**Town of Marshfield  
Emergency Watershed Program**

**Addendum No. 1  
September 18, 2024**

DSR NO. 5041-030  
40 LOWER DEPOT ROAD  
STREAMBANK PROTECTION - PLAN

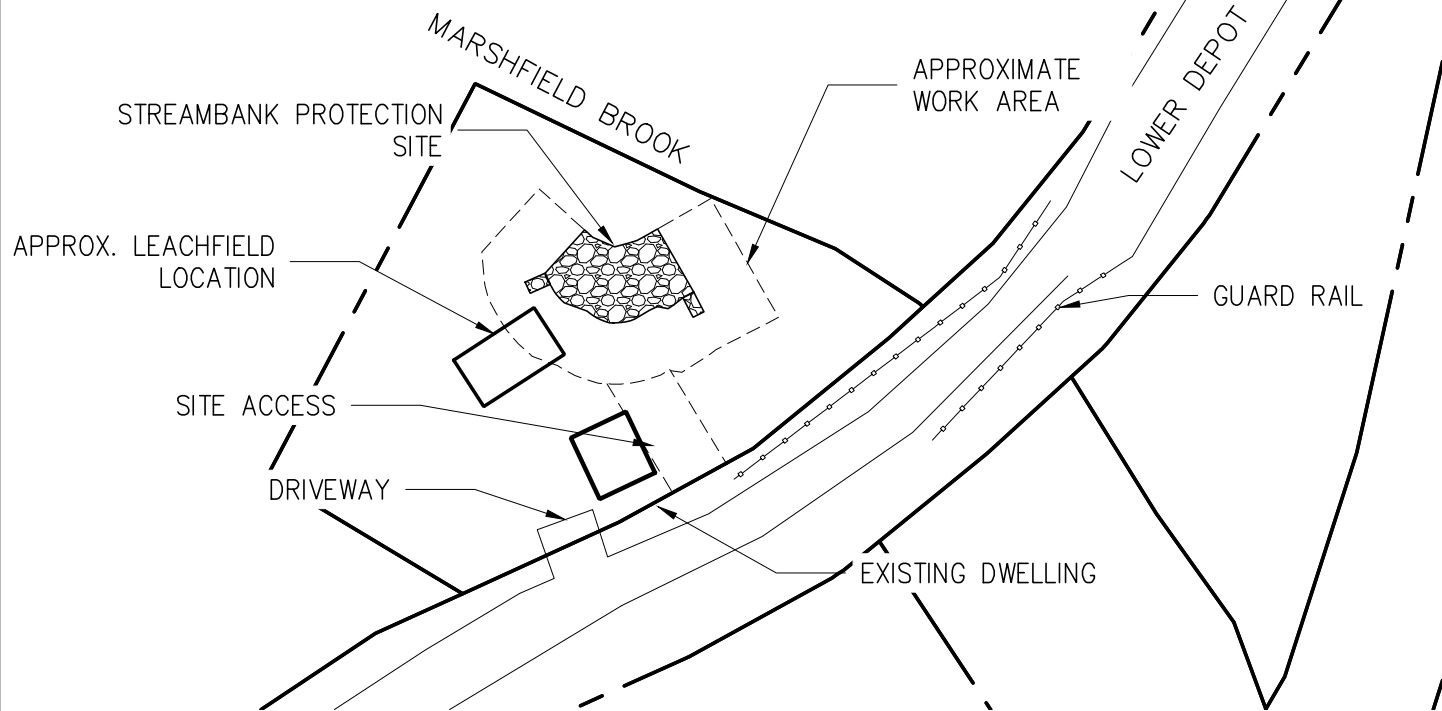
1. Delete Sheets 11-12 and all work at 83 Creamery Street.
2. Attached is revised Sheet No 8 (Rev 1).
3. Attached is revised Sheet No 9 (Rev 1).
